DUNE ColdADC FDR

Carl Grace, on behalf of ColdADC Design Team – July 21, 2021

Executive Summary

Bandgap Opamp Flavor

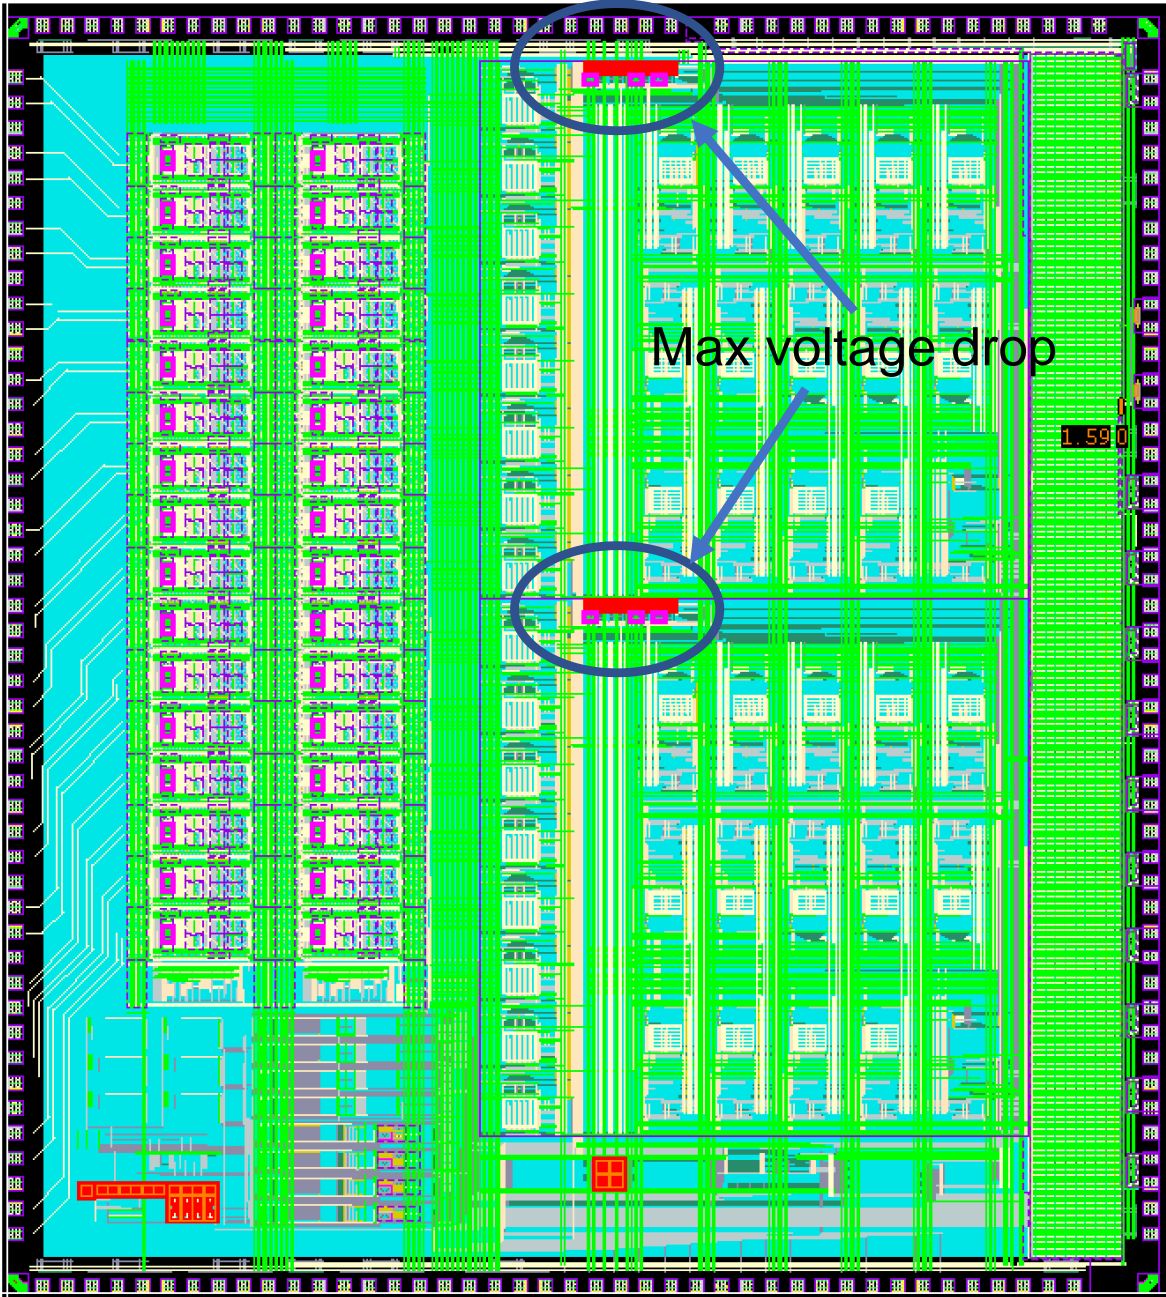
- Issue: Opamp of wrong polarity included in P1 bandgap reference generation circuit
- Effect: VDDA needed to run at elevated supply for circuit to function correctly
- Root cause: Design error
- Fix: Correct opamp inserted into bandgap design
- Result: Bandgap reference in P2 worked as expected

Autocalibration

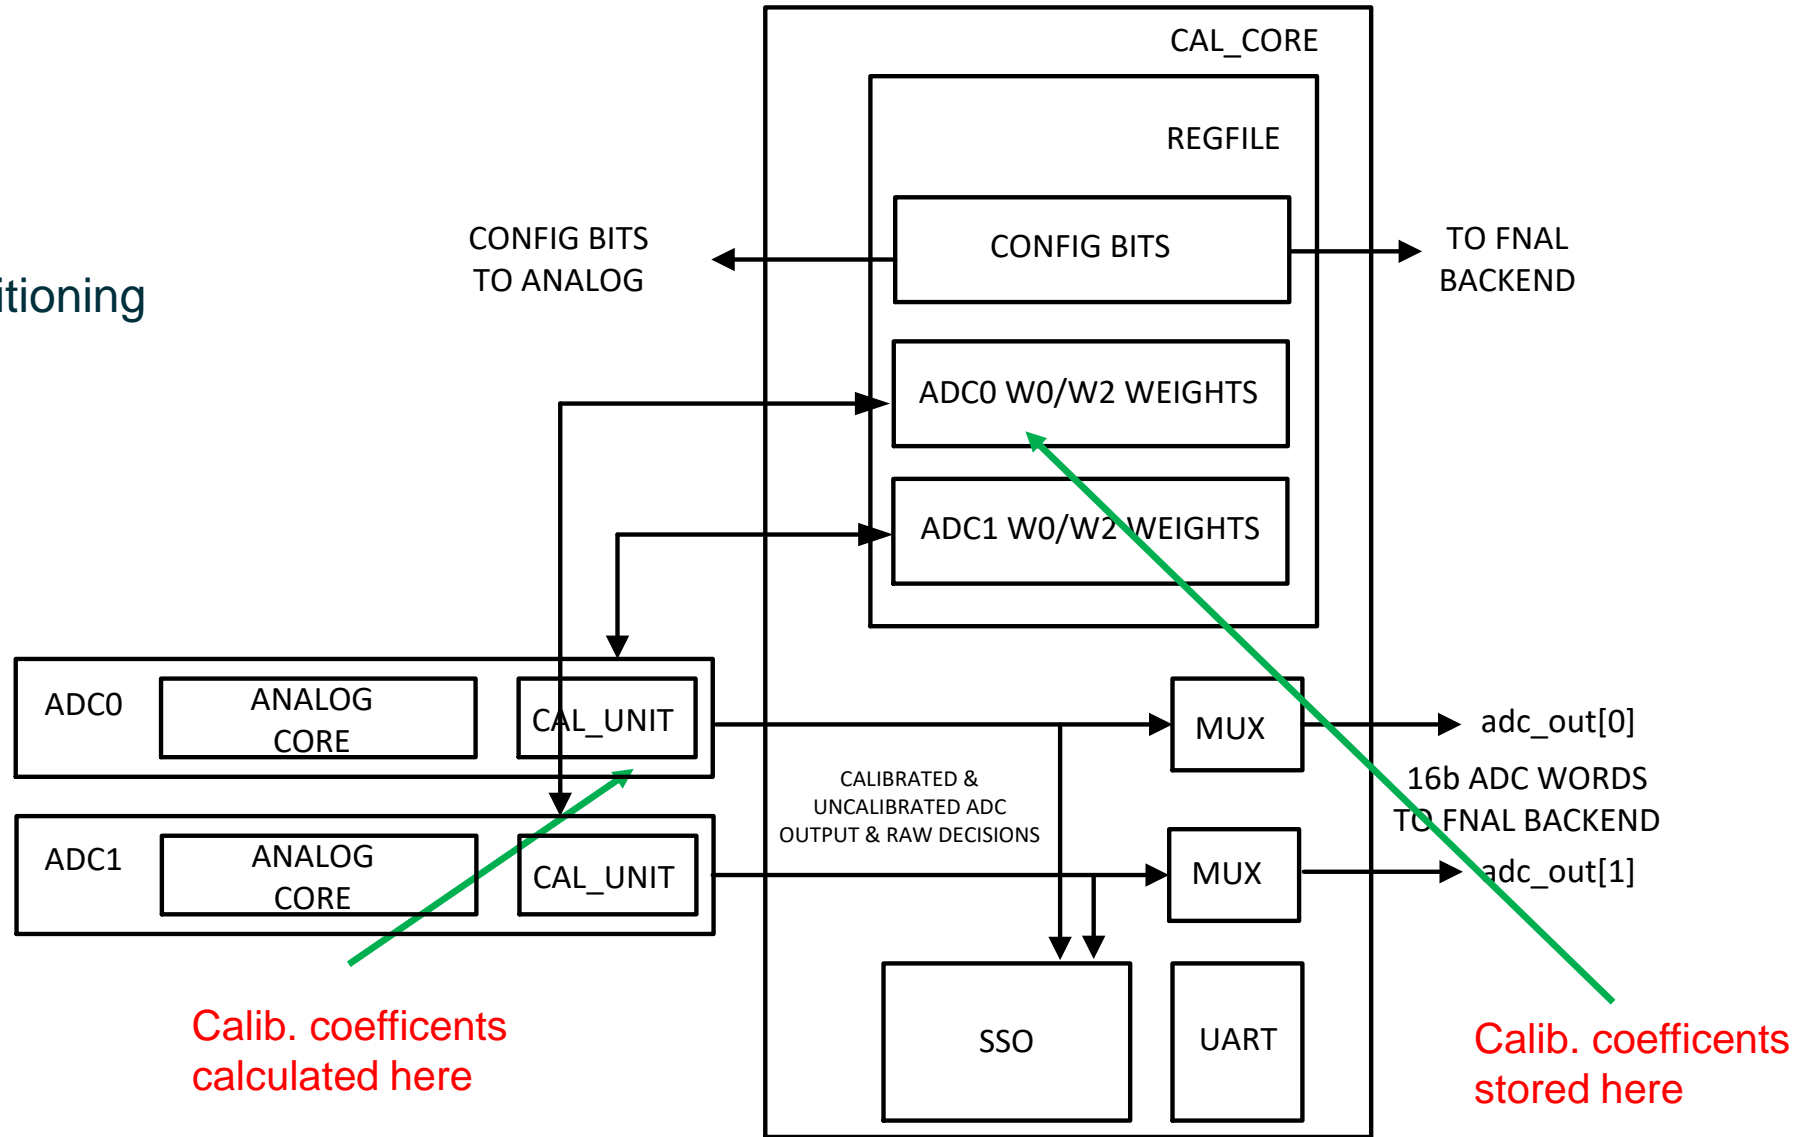
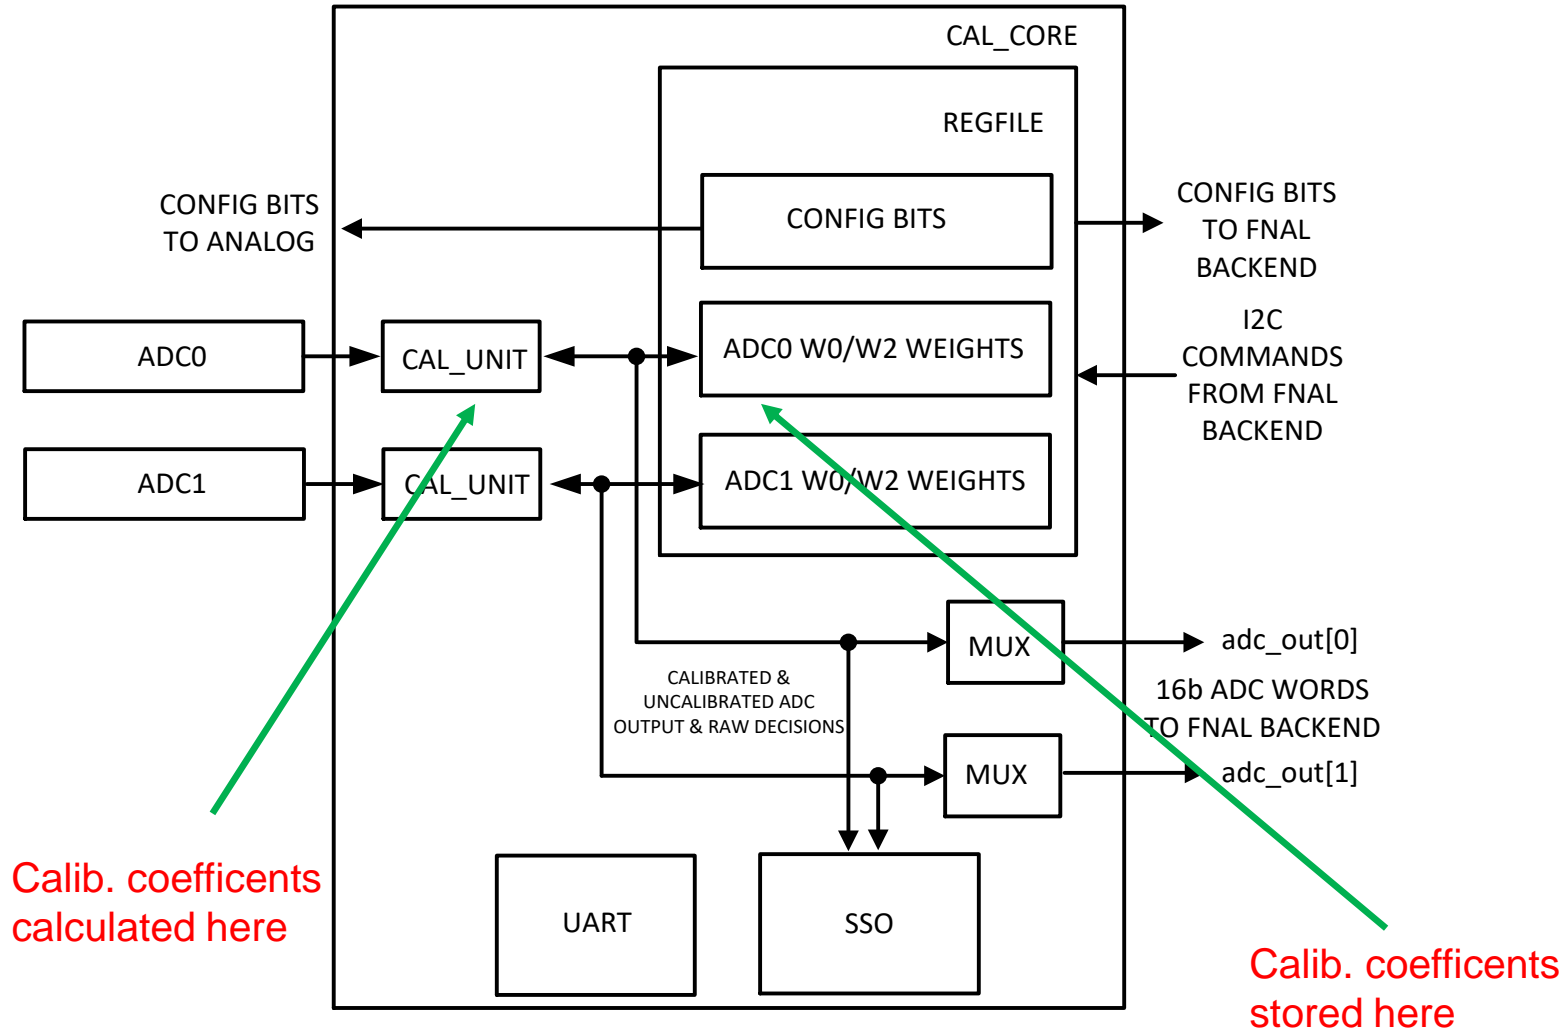
- Issue: The automatic calibration function in P1 failed to operate correctly
- Effect: While evaluation of the calibration algorithm was still possible, required calculating calibration correction data off-chip and then reloading the calibration weights on chip (not suitable for fielding in practical detector)
- Root cause: Miscommunication between design teams, and separation of different functional unit in separate synthesized blocks
- Fix: Repartitioned design to use a single, monolithic digital block. Implementing more extensive verification, improved communication through use of shared documents and meetings
- Result: Autocalibration fully functional in P2 without problems

ADC Linearity

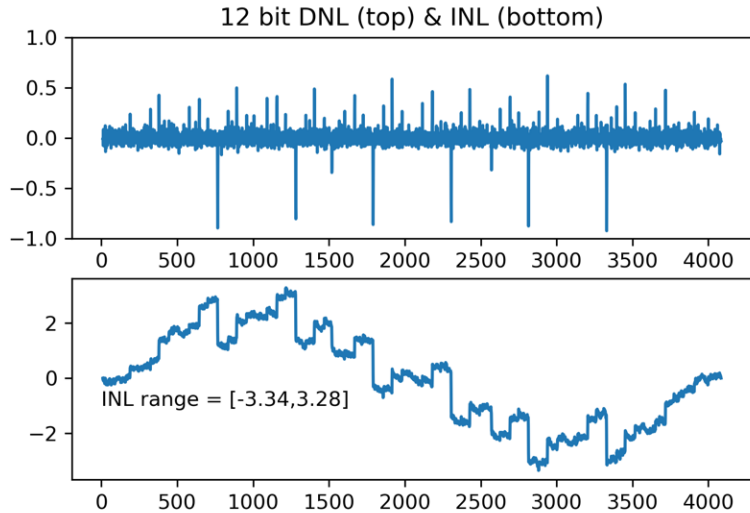
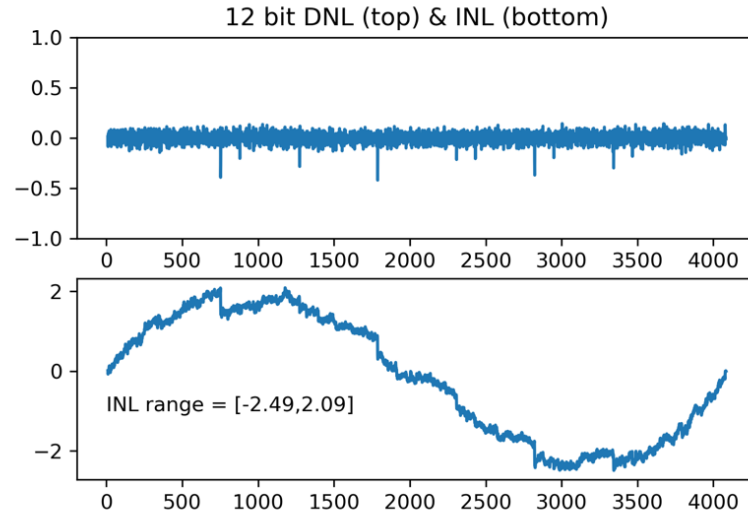
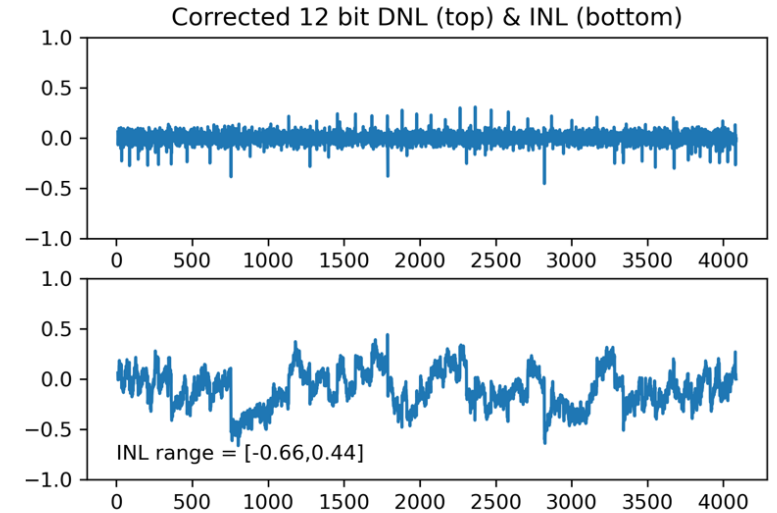
- Issue: The ADC linearity was not as good as expected (based on simulation)
- Effect: Additional nonlinearity in P1 above expectations
- Root cause: Several issues, including insufficient opamp gain and insufficient swing across corners
- Fix: Op amps were redesigned to improve swing and increase gain
- Result: Linearity was improved relative to P1. Residual nonlinearity consistent with dielectric absorption in the capacitors used to implement the ADC stages (stable correction possible)

ADC Crosstalk

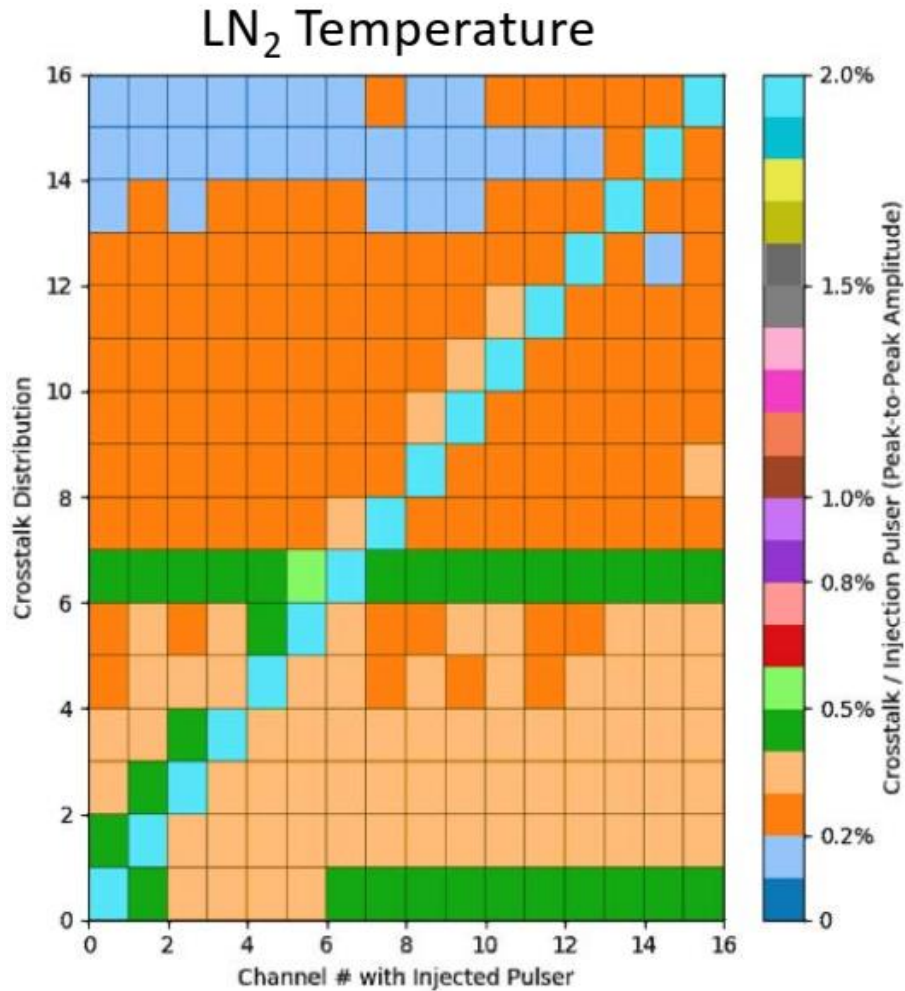
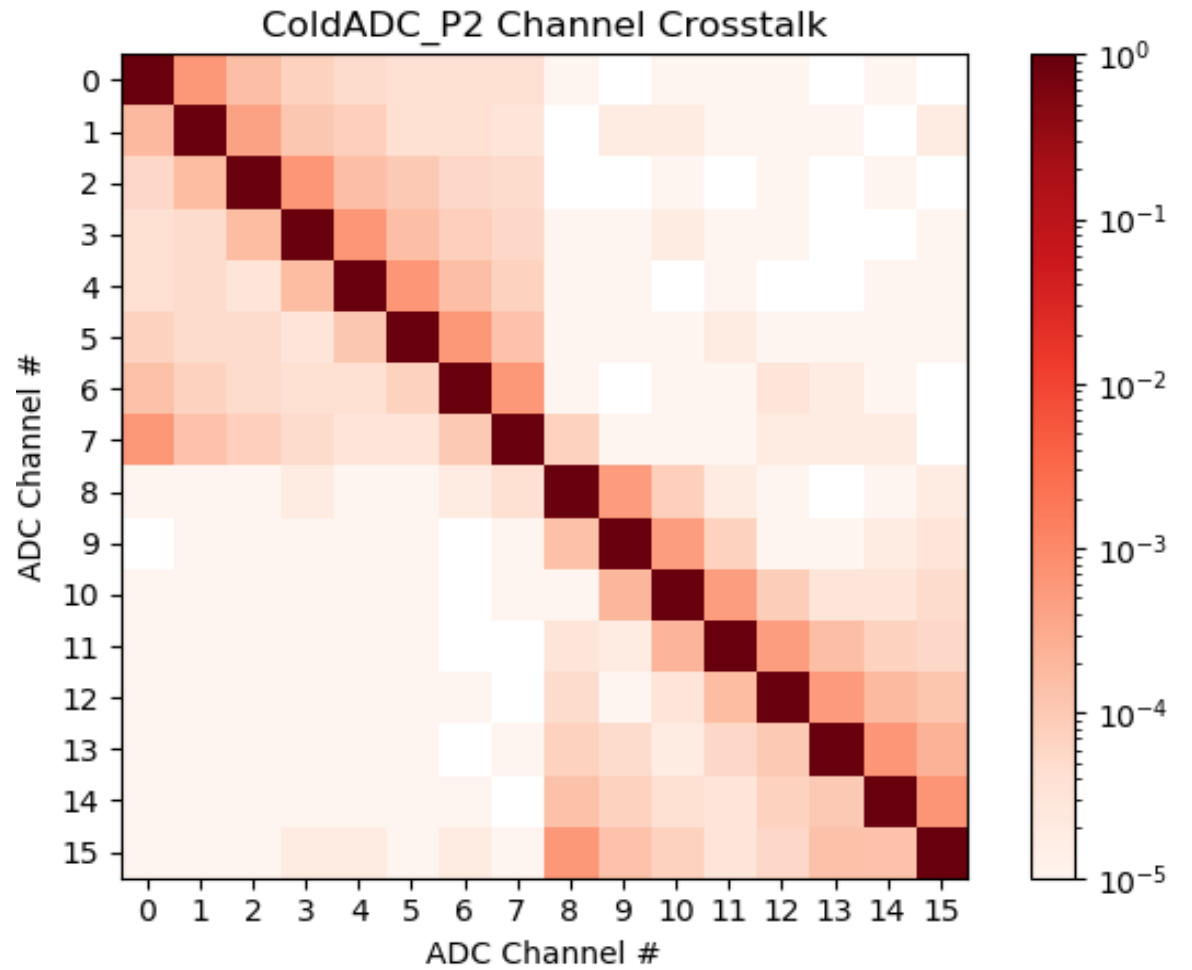
- Issue: While not critical, there was evidence of a low level of crosstalk ($\sim 0.5\%$) between channels.
- Effect: Limited performance of some channels
- Root cause: Insufficient bandwidth in the mux (too high on-resistance in switches) leading to kickback and mutual capacitive coupling between channels
- Fix: Improve BW to mitigate memory effect (kickback) and reduce channel-to-channel coupling via layout optimization
- Result: Crosstalk improved to 0.06% (almost order-of-magnitude improvement)

Digital Overflow

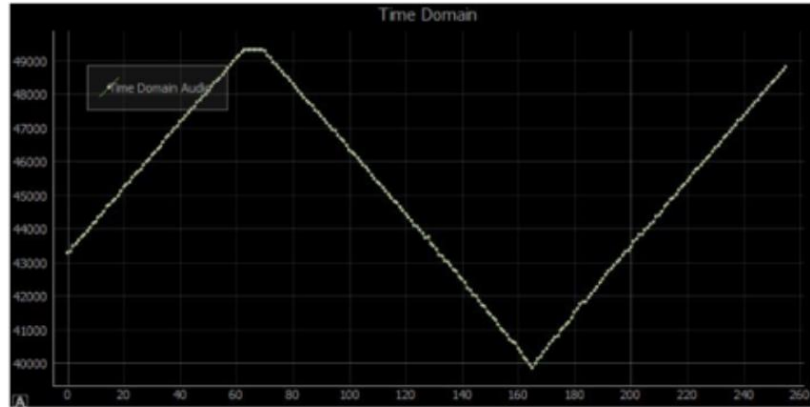
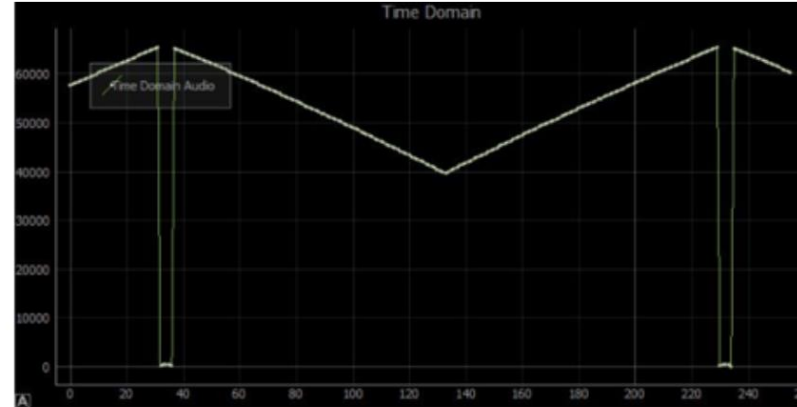
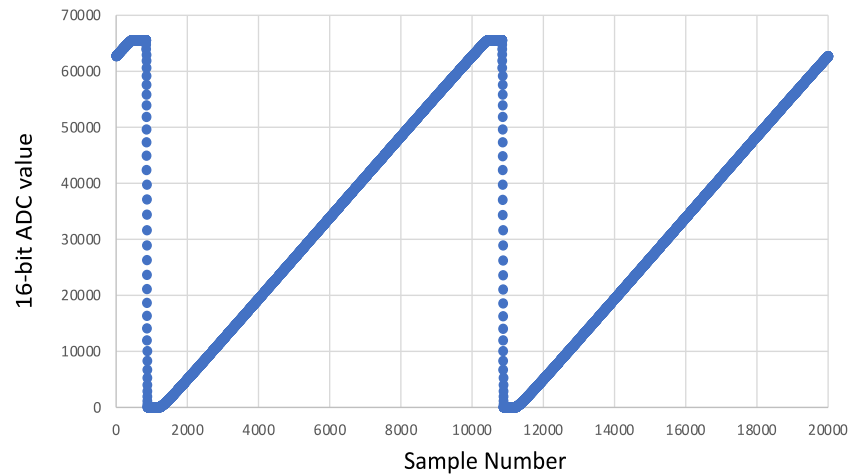
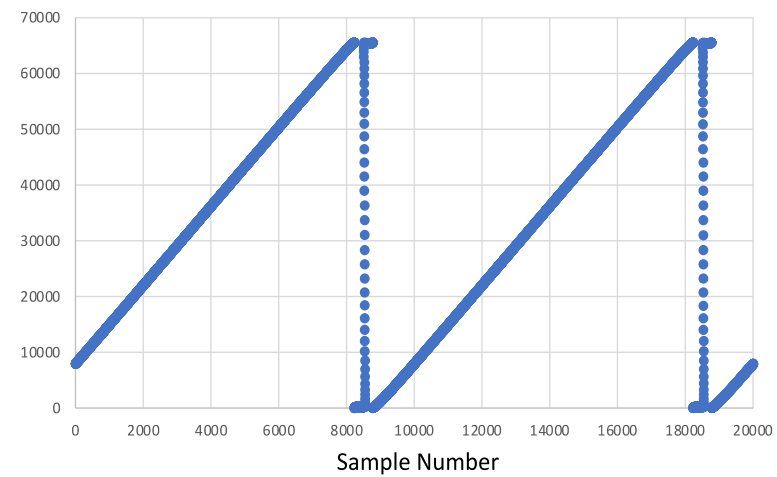
- Issue: If the sum of all ADC stages gains $> 2^{15}$, overflow (or underflow) possible
- Effect: Overflow observed in testing of P1
- Root cause: Capacitor mismatch can cause some ADC stages to have gain > 2 .
- Fix: Implement digital overflow monitor to detect overflow condition and pin the ADC output to appropriate value
- Result: Overflow monitor demonstrated to work as expected
